Preliminary Plat - Kum & Go No. 489

Location: 4020 W. Battlefield

PRELIMINARY PLAT – KUM & GO No. 489

**PRELIMINARY PLAT OF
KUM & GO NO. 489
NW 1/4 OF THE SW 1/4 OF SECTION 5, T-29-N, R-22-W
CITY OF SPRINGFIELD, GREENE COUNTY, MISSOURI
PRELIMINARY PLAT**

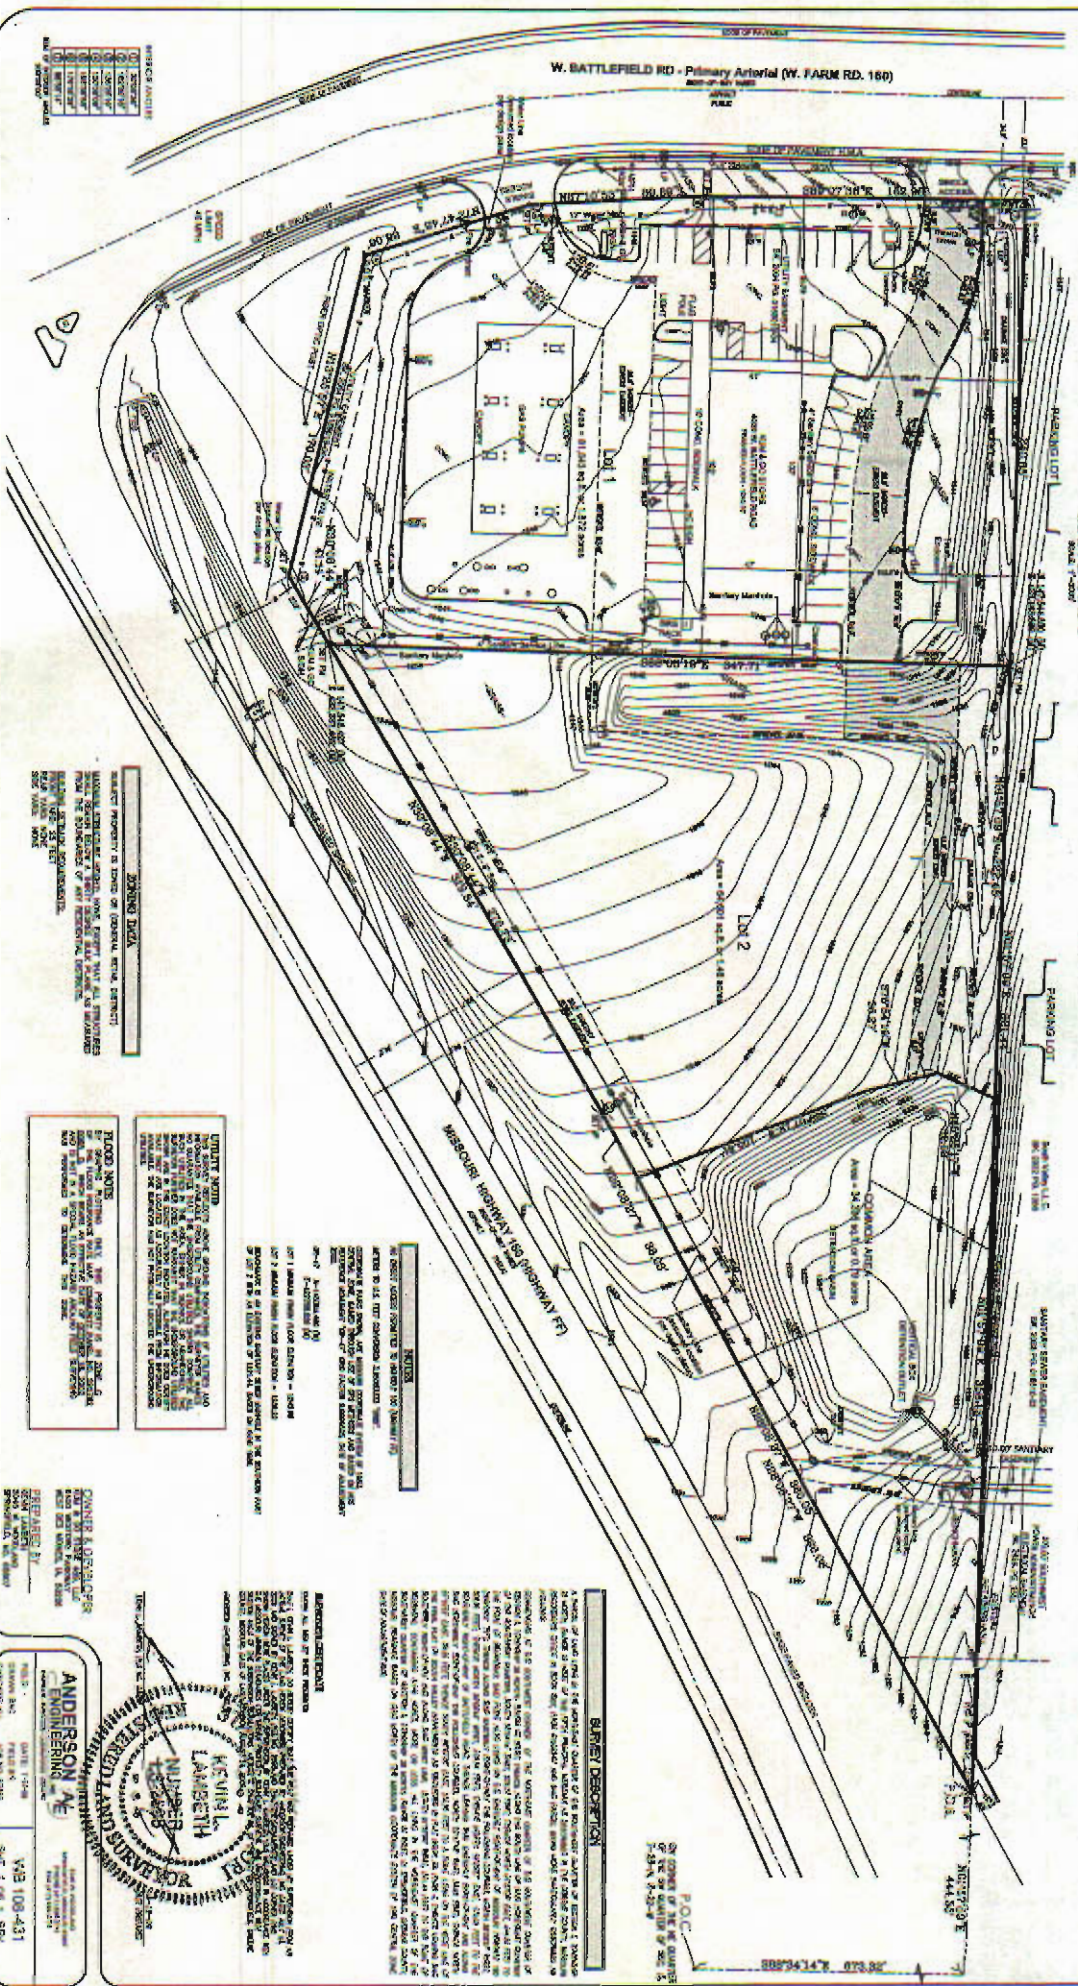
1. The east-west portion of the ingress-egress easement on proposed Lot 2 should be 25 feet to allow for better vehicular access through the two 90 degree turns.

1: The fire department may require additional fire lanes to be dedicated to serve potential development on lot 2.

2: Need to verify that a minimum of 20% of lot 1 is in open space.

3: Need to verify that the exterior lighting from the existing development will meet the standards at the proposed new lot line.

4: This site will be considered a "premise" with respect to signage. Need to note this on the plat.

Main extensions will be required along with related dedication of easements.

1. Detention / water quality basin is required to be platted in Common Area. According to Section 5-2300 of the Zoning Ordinance, Common Area cannot be platted as part of an individual lot.
2. As mentioned in the pre-subdivision comments, an as-built survey is required of the existing detention basin. This survey will certify that the volume and outlet structure of the existing facility matches the building plan for Kum N Go (BLD2008-00555). This final copy of this survey will be submitted on mylar and filed at the City. If the survey varies from the planned design, engineering calculations and public improvements will be necessary for the subdivision.
3. Additional drainage easements are required on Lot 2 in order to convey all of the surface runoff from Lot 1 to the detention basin.
